**RE: PETITION NO. 1530** – American Tower Corporation petition for a declaratory ruling, pursuant to Connecticut General Statutes §4-176 and §16-50k, for proposed modifications to an existing telecommunications facility located at 401 Lopus Road, Beacon Falls, Connecticut, request for revision.

Therefore, Airosmith Development respectfully requests a revision to replace Attachment B: Signed and Stamped Construction Drawings of Petition No. 1530 with the attached, updated construction drawings, dated August 11<sup>th</sup>, 2022. Thank you for your time and consideration.

ATC SITE NAME: BEACON FALLS CT  
 SITE NUMBER: 370641  
 SITE ADDRESS: 401-411 LOPUS ROAD  
 BEACON FALLS, CT 06403

<b>SITE PLAN</b>	
SHEET NUMBER: <b>C-101</b>	REVISION: <b>1</b>

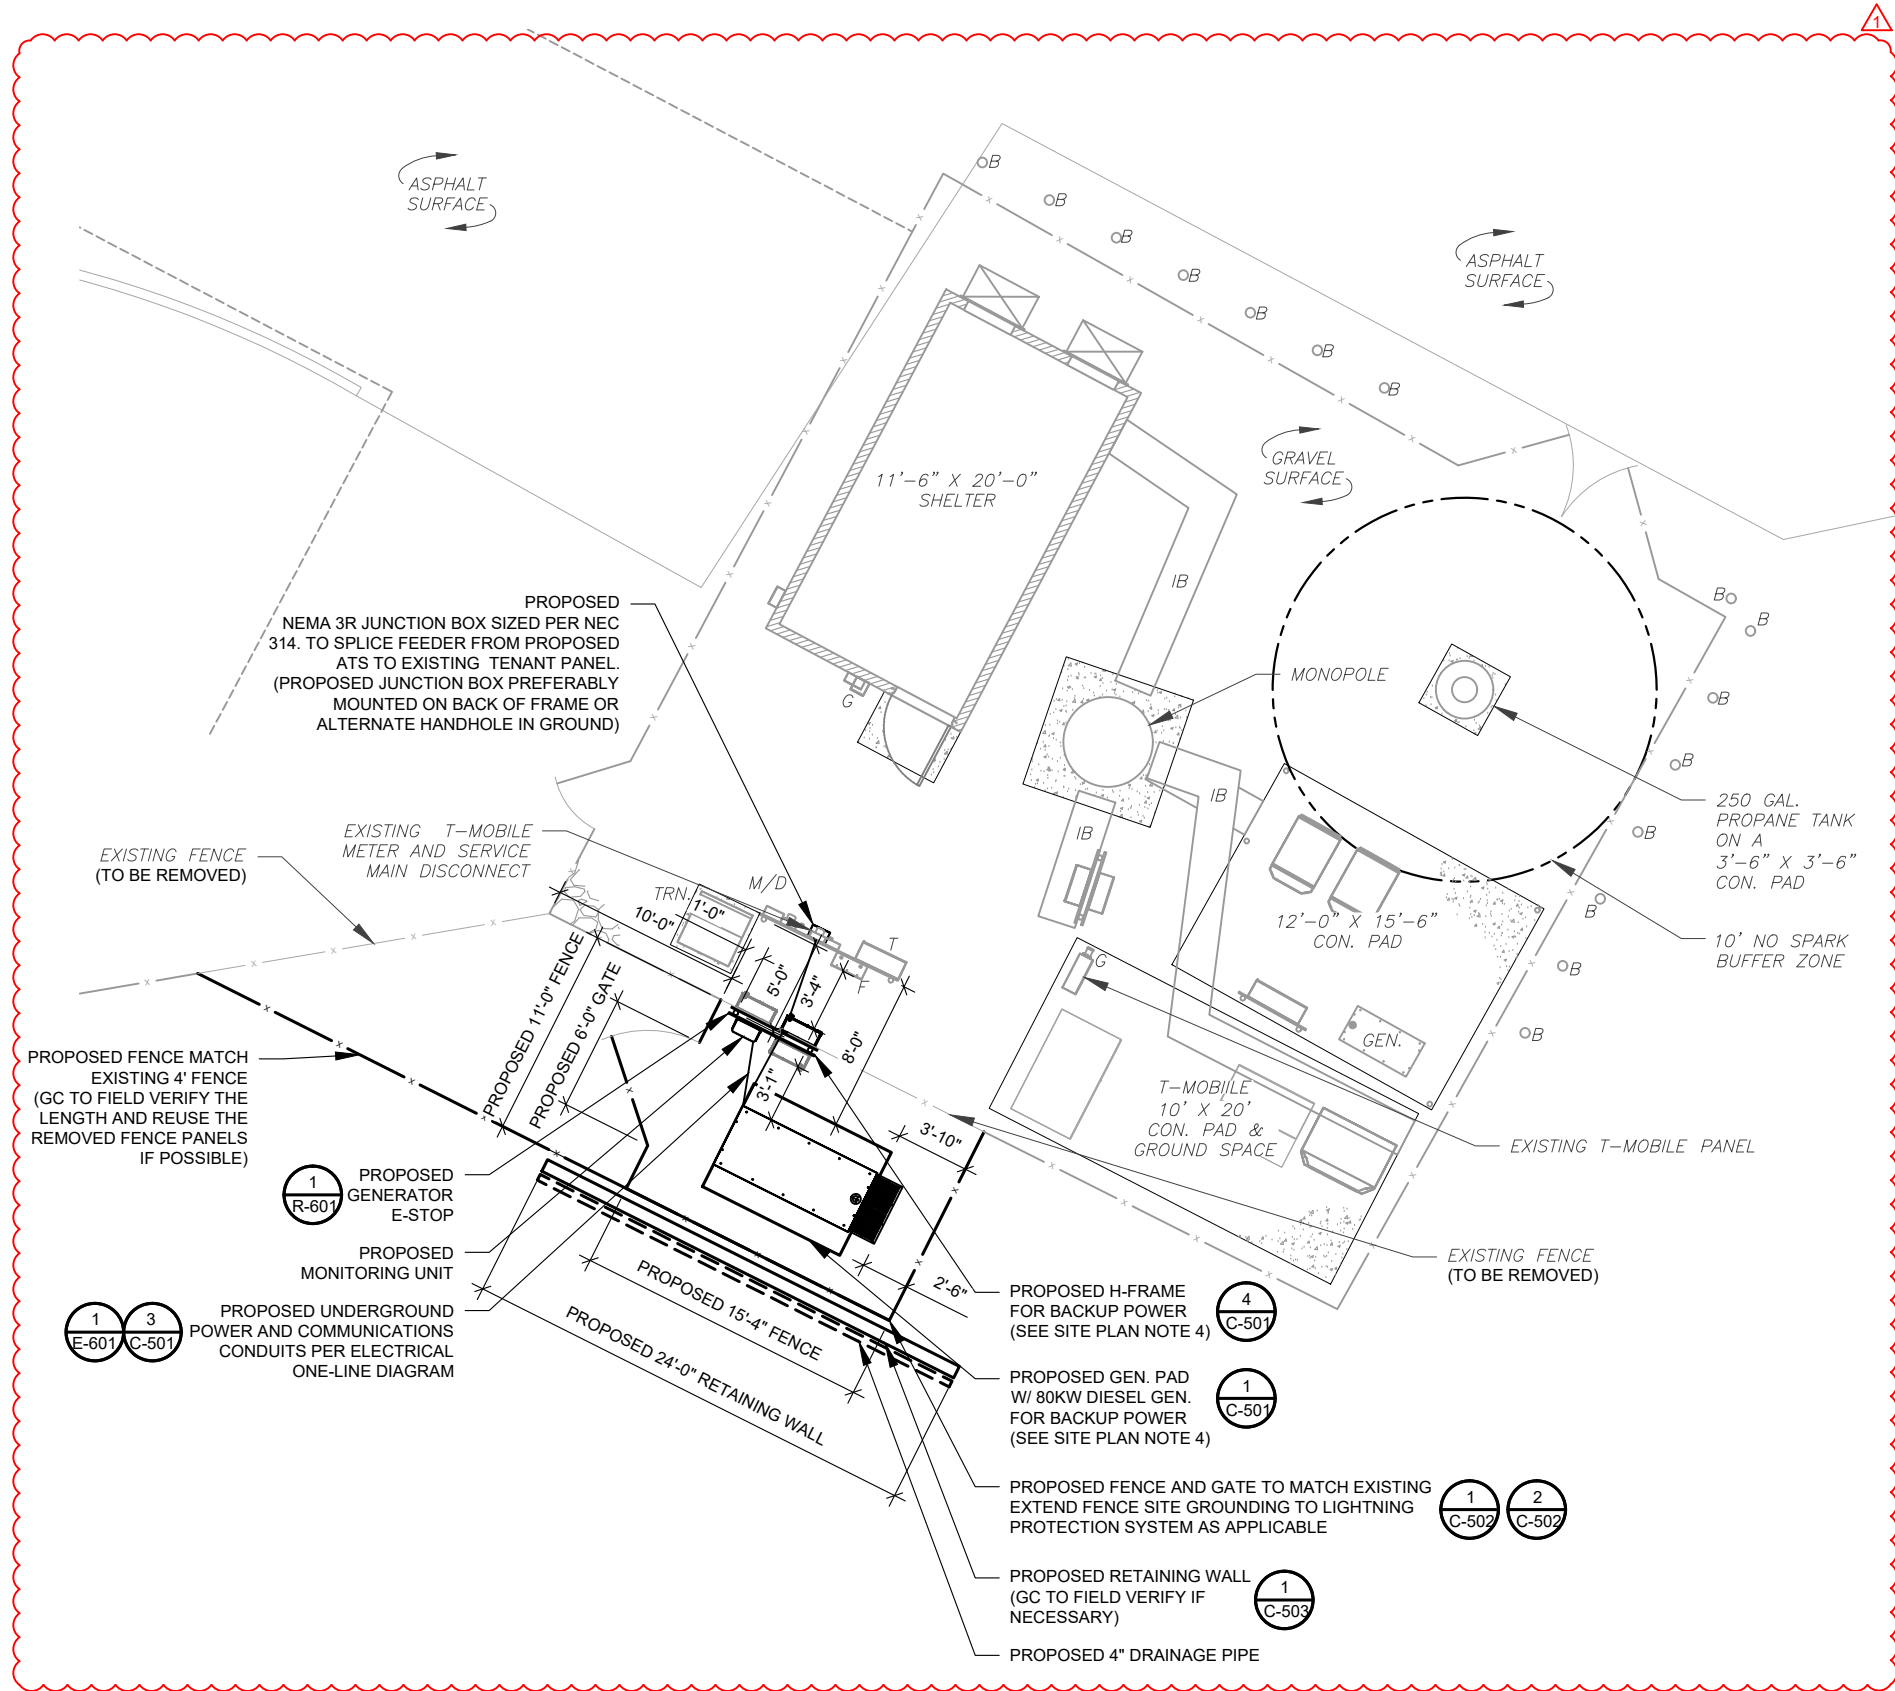
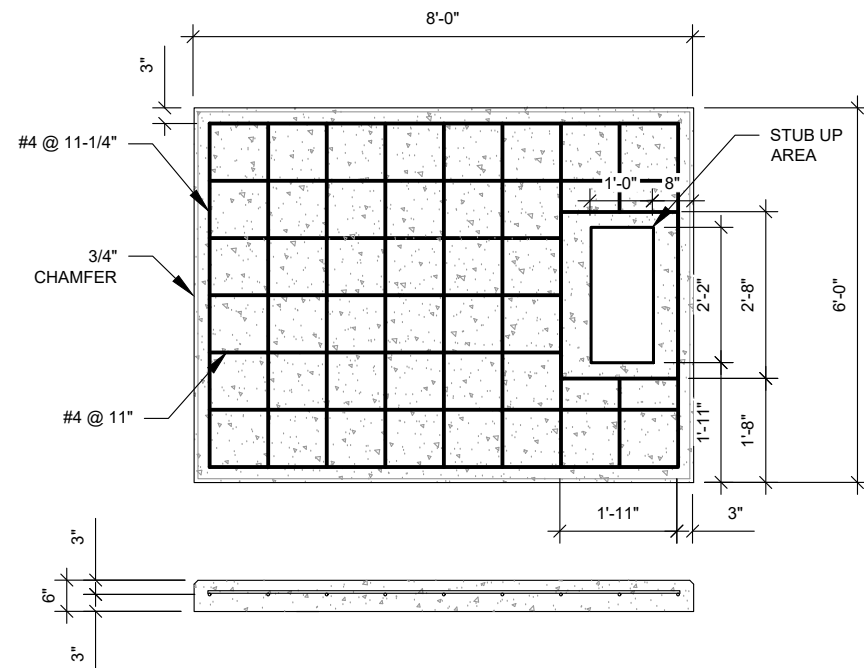
On July 12<sup>th</sup>, 2022, Airosmith Development submitted Petition No. 1530 on behalf of American Tower Corporation (“ATC”) for a declaratory ruling for proposed modifications to an existing telecommunications facility. Since then, ATC has decided they wish to change the layout of the proposed expansion and depict a retaining wall that may be required for the proposed expansion.

REV.	DESCRIPTION	BY	DATE
0	FOR CONSTRUCTION	FR	03/25/22
1	FENCE RELOCATION	AM	08/11/22
